## PRODUCT CHANGE NOTICE

**PCN#20-023****NOTIFICATION DATE: June 8, 2020****MODEL(S) AFFECTED:**

<b>BPF-300A-1+</b>	<b>BPF-1000A-1+</b>
<b>BPF-V300+</b>	<b>BPF-V1000+</b>

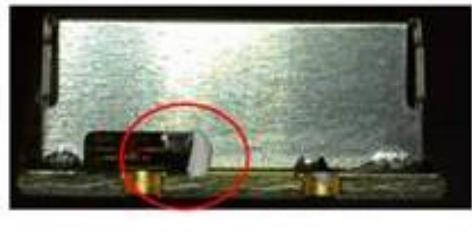
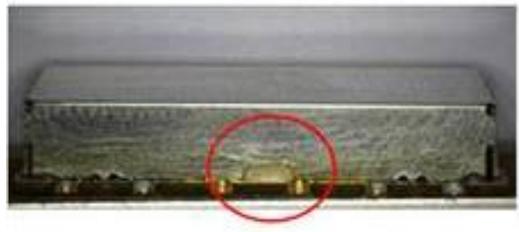
To improve the cover securing process, changed the securing position from longer side to shorter side.

No change to **FIT** (dimension) or **FUNCTION** (performance).  
Change to **FORM** (appearance) due to Epoxy position changed.
